August 29, 2007 Project SJ809-ST1-X SAP: 135442

Request for Case Closure Shell Service Station 809 East Stanley Boulevard Livermore, California

Subject: Fuel Leak Case No. RO0002524 and Geotracker Global ID T0600162519, Shell#13-5442, 809 East Stanley Boulevard, Livermore, CA 94550

## FIGURE 3 SENSITIVE RECEPTOR LOCATION MAP SENSITIVE RECEPTORS WITHIN 2,000

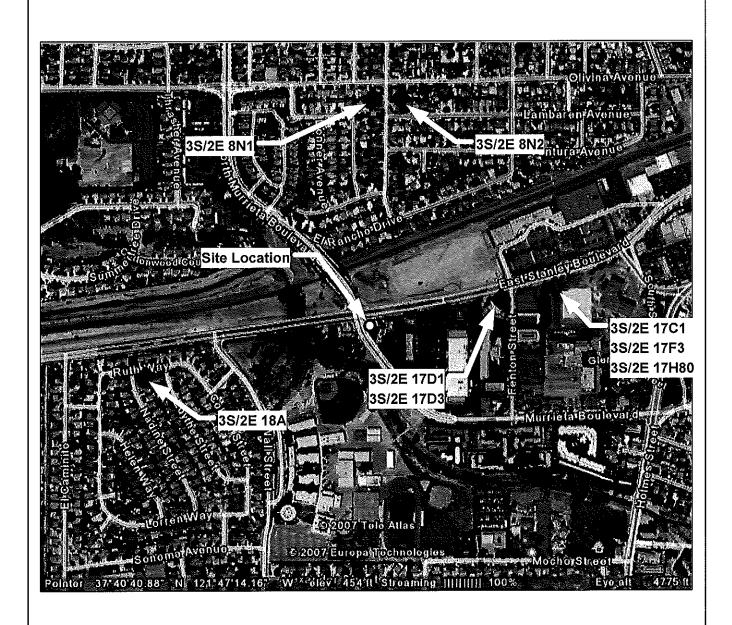
- 3. Detailed Well Survey. Previous well surveys for the site appear to only include public drinking water supply wells located on Geotracker. Consideration of only public supply wells is not sufficient to assess whether there are receptors for the site. We request that you conduct a well survey to locate all water supply wells (active, inactive, standby, decommissioned, and abandoned wells) within a 2,000-foot radius of the site. Submittal of maps showing the location of all wells identified in your study, and the use of tables to report the data collected as part of your survey are required. Please provide a table that includes the well designation, location, total depth, diameter, screen interval, date of well installation, current status, historic use, and owner of the wells. In addition, please provide well logs and completion records for any wells downgradient from the site that are potential receptors for the site. We recommend that you obtain well information from the Zone 7 Water Agency and State of California Department of Water Resources, at a minimum. Please report your results in the Well Survey Report requested below.

wells where located within the specified radius. Sensitive receptor locations can be found in Figure 3 and Table 1 shows all well completion information available from the DWR records.

The sensitive receptor map (Figure 3) indicates only two potential supply wells located approximately 4,800 feet down to cross gradient, well beyond the 2,000 foot radius requested.

Location Plan

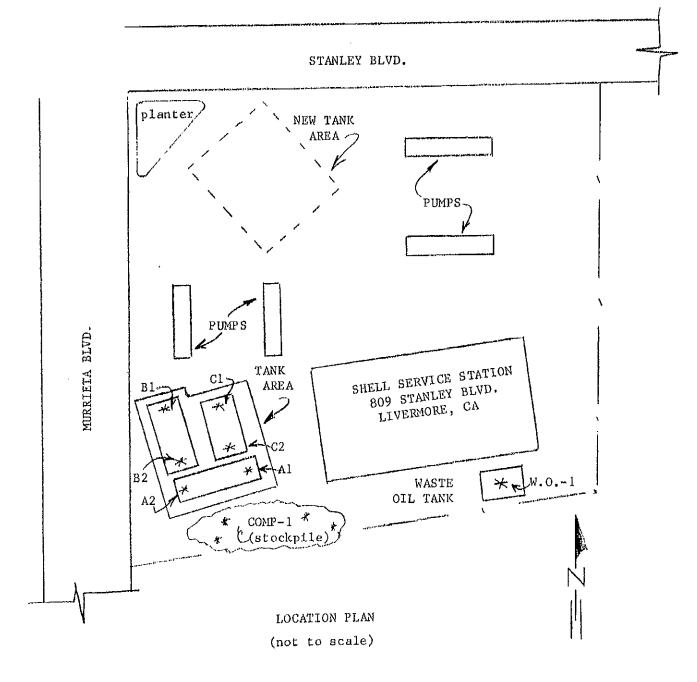
1. Tank Removals in Southern Portion of Site. Sometime after 1989, the fuel USTs were apparently relocated from the southern portion of the site to their current location near the corner of Murletta and Stanley Boulevards. The "Request for Case Closure Letter," indicates that no reports that describe removal and location of the fuel USTs after 1989 could be located. We request that you review your files and files from Livermore-Pleasanton Fire Department in order to confirm the removal of these tanks and provide information on the conditions encountered during removal. As requested below, please submit this information along with a copy of the Kaprealian Engineering, Inc. report that describes the fuel and waste oil UST removal in November 1986.

In a December 4, 1986 report, Kaprealian Engineering, Inc. (Kaprelian) documented field observations and soil sampling following the removal of three gasoline underground storage tanks (USTs) and one waste oil UST at the site on November 10 and 11, 1986 (Attachment B). The site map in this report shows an area in the northern part of the site labeled "new tank area." This map and the fact that Delta has been unable to locate any information regarding a later tank replacement/removal, including a file review at the Pleasanton Fire Department, would indicate the fuel tanks were relocated to this area following the 1986 UST removal, not at a later date as stated in the previous Delta closure request.

The December 4, 1986, Kaprelian report states the tanks were removed and appeared to be in good condition. No fuel related odor was noted. Soil discoloration or the presence of groundwater was not observed. Six soil samples were collected beneath the locations of the fuel tanks and one beneath the waste oil tank. Analytical results of these samples did not detect the presence of THC, BTX and VOCs.
